From: David Soule <david@riograndeengineering.com>
Sent: Tuesday, April 04, 2017 2:17 PM
To: Al-Najjar, Marwa G.
Cc: Biazar, Shahab
Subject: RE: MESA COLD STORAGE REVISED SUBMITTAL H13D108
Attachments: revised grading plan070417.pdf

<div>ENGINEER'S SEAL</div> <div>DAVID SOULE NEW MEXICO 14522 REGISTERED PROFESSIONAL ENGINEER</div> <div>DAVID SOULE P.E. #14522</div>	MESA COLD STORAGE	DRAWN BY WCVJ
	GRADING AND DRAINAGE PLAN	DATE 4-03-17
	<div>Rio Grande Engineering</div> <div>1608 CENTRAL AVENUE SE SUITE 201 ALBUQUERQUE, NM 87106 (505) 872-0999</div>	21707-LAYOUT-2-07-17
		SHEET # —
		JOB # 21707

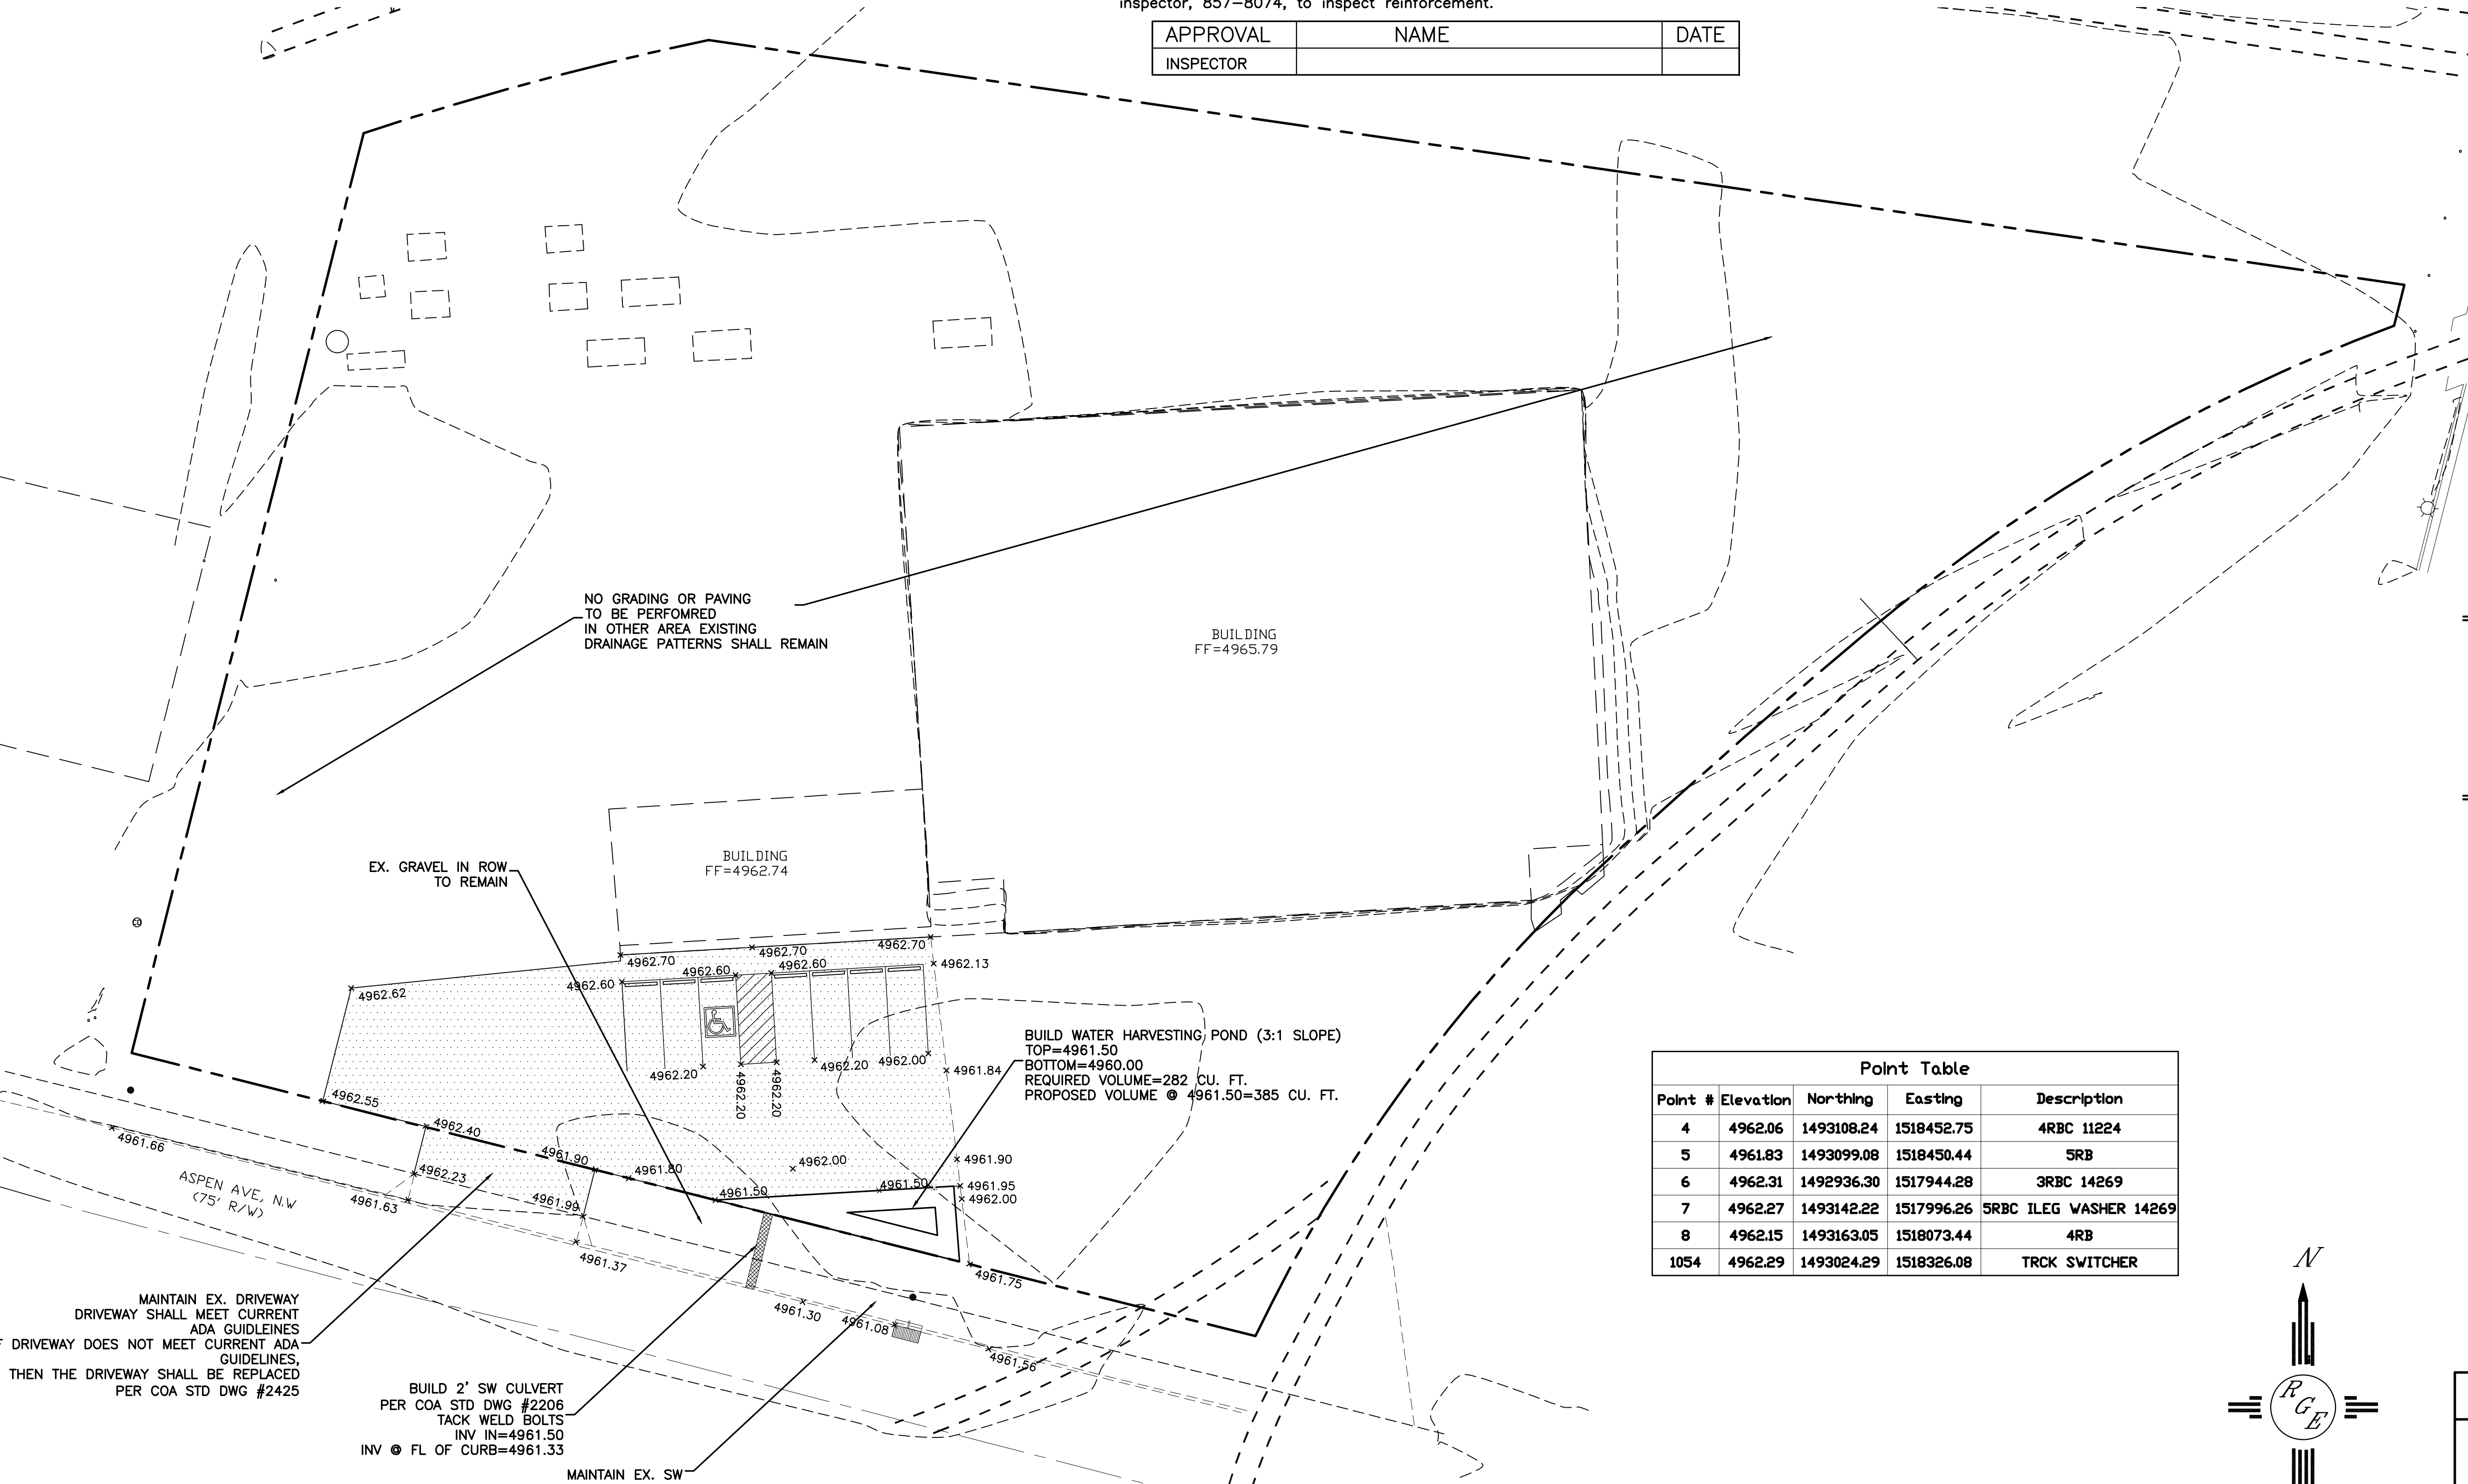
David,
The water will spill through the sidewalk and it will not spill through the sidewalk culvert.

Fix the bottom elevation of the pond.

- Flow line elevations along the south side of the site. **ADDED**
- It appears there is a low spot elevation on the east side of the parking lot it will cause water harvesting. **THE 61.85 DRAINS TO THE 61.50**
- The sidewalk culvert invert shouldn't be the same as top of pond elevation.
WE LOWERED THE POND SO THE HARVEST VOLUME IS BELOW 61.50.
THE CULVERT INVERT IS BASED UPON EXISTING FLOW LINE

Marwa, thank you for catching that. I have adjusted the spot elevations at the back of sidewalk. the sidewalk is higher than the flow line which the culvert invert ties to, so i adjusted the grades at the west side of pond to assure the water goes thru the culvert. A hard copy of this is coming down by end of the day

Marwa, I believe i want the pond bottom to be 4960.00 as shown. The pond spills at 4961.50 and I am providing the first flush volume in that depth. Please confirm that is ok, or please expand on the comment, i believe the plan is correct.
Thank you
David Sould
